City of Ferguson 110 Church Street Ferguson, MO 63135

ROBERT AVENUE STREET IMPROVEMENTS STP-S 5583 (610)

ADDENDUM #1

Date: August 21st, 2025

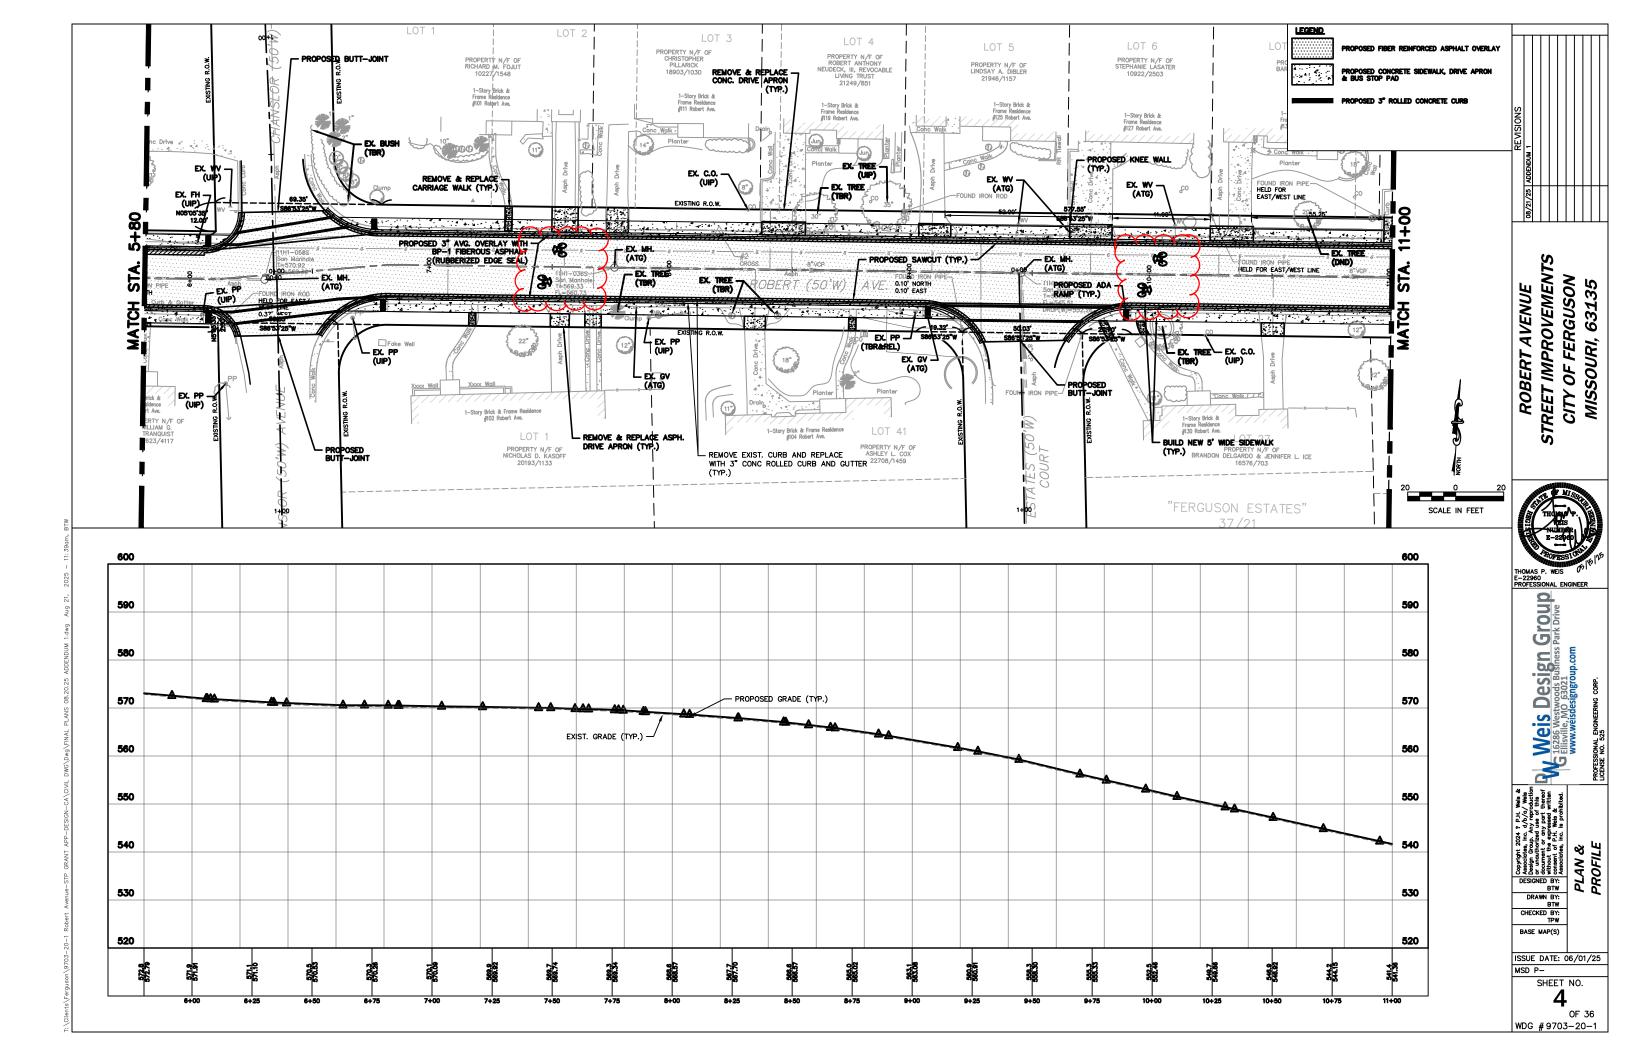
- a. PLAN SHEET 3 PLAN AND PROFILE
 - ADDED SHARE THE ROAD (CHEVRON)
- b. PLAN SHEET 4 PLAN AND PROFILE
 - ADDED SHARE THE ROAD (CHEVRON)
- c. PLAN SHEET 5 PLAN AND PROFILE
 - ADDED SPEED HUMP
 - ADDED CONCRETE PAD AND BICYCLE RACK
 - ADDED SHARE THE ROAD (CHEVRON)
- d. PLAN SHEET 6 PLAN AND PROFILE
 - ADDED SHARE THE ROAD (CHEVRON)
 - ADDED SPEED HUMP
 - ADDED SOLAR RECTANGULAR RAPID FLASHING BEACONS
- e. PLAN SHEET 7 PLAN AND PROFILE
 - ADDED SHARE THE ROAD (CHEVRON)
- f. PLAN SHEET 9 PLAN AND PROFILE
 - ADDED SHARE THE ROAD (CHEVRON)
- g. PLAN SHEET 35 DETAIL SHEET
 - ADDED SHARE THE ROAD (CHEVRON) DETAIL
 - ADDED SPEED HUMP DETAIL

h. ATTACHMENT A

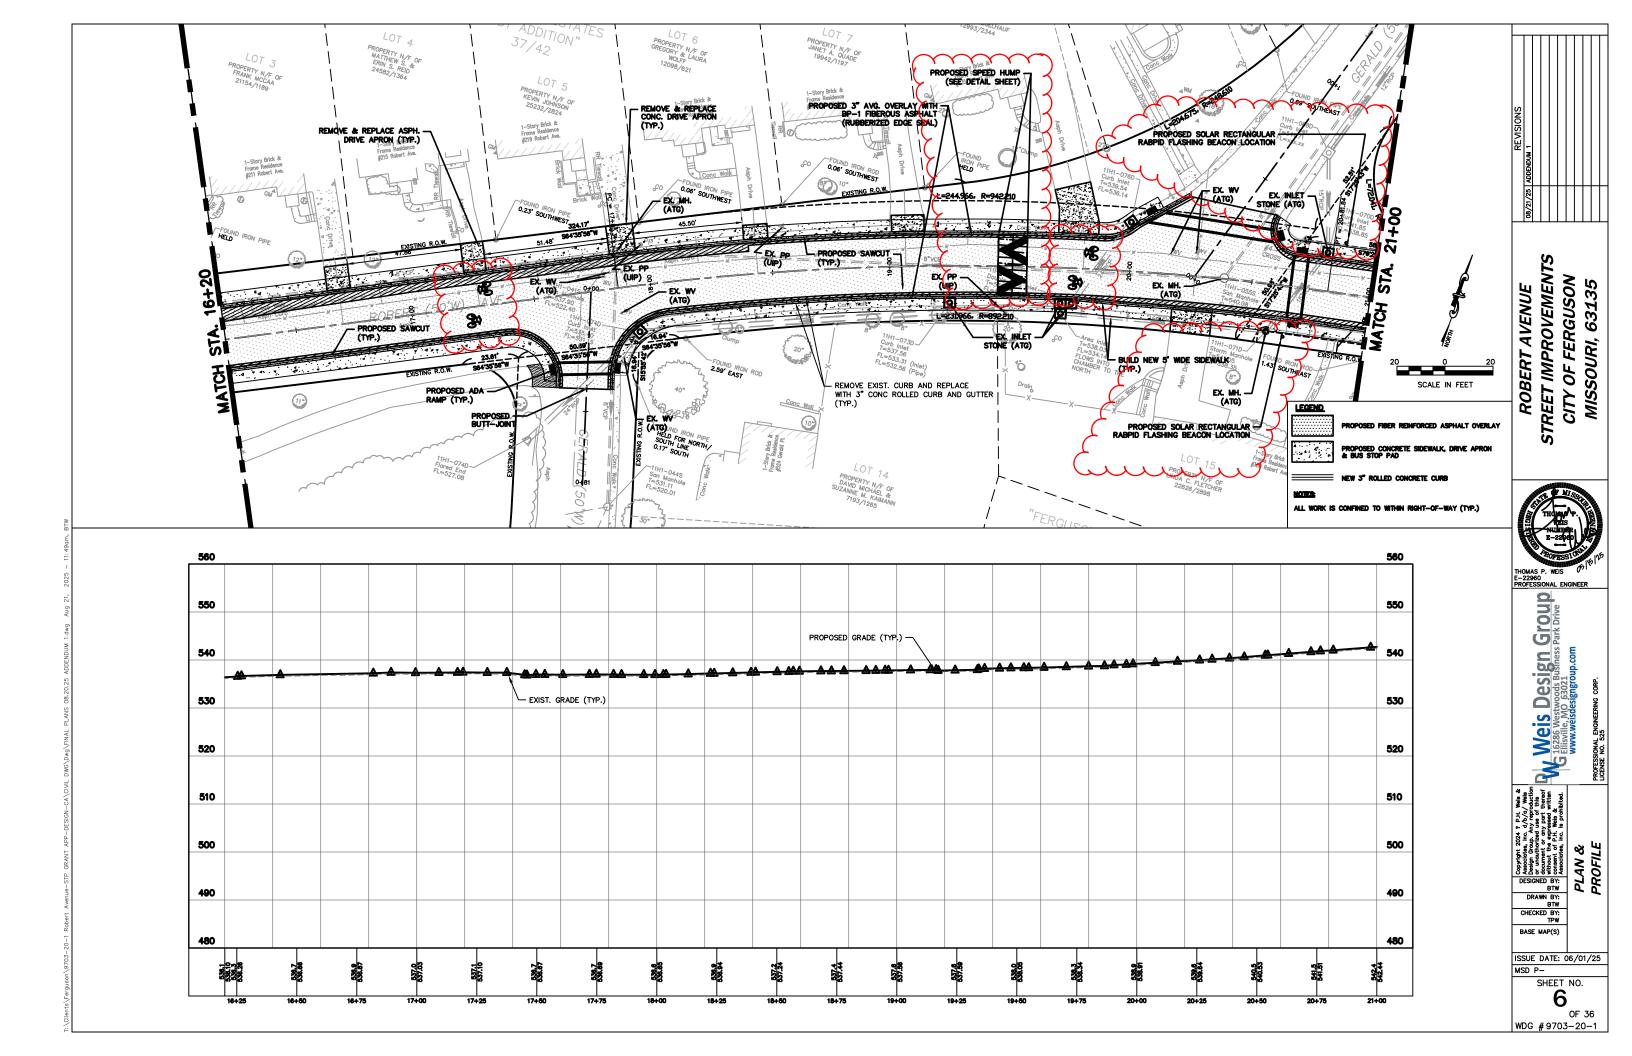
- ADDED LINE ITEM NUMBERS
- ADJUSTED QUANTITY "REMOVE ASPHALT PAVEMENTS (INCLUDES ROCK SUBGRADE, SAWCUTS AND FLOWABLE FILL CONCRETE) TO 1,200 SQUARE YARDS.
- ADJUSTED MILLING QUANITY TO SAY "1"THICK, 6' EDGE MILL OF EXISTING AREAS "
- ADDED LINE ITEM " 4" DOUBLE LINE PAVEMENT MARKING (YELLOW) "
- ADDED BICYCLE RACKS ID NUMBER TO THE LINE ITEM
- ADJUSTED QUANITY FOR LINE ITEM "BICYCLE CHEVRON PAVEMENT MARKINGS" TO 22 EA.
- ADDED LINE ITEMS 30,31,32 & 33 FOR THE SPEED HUMPS.
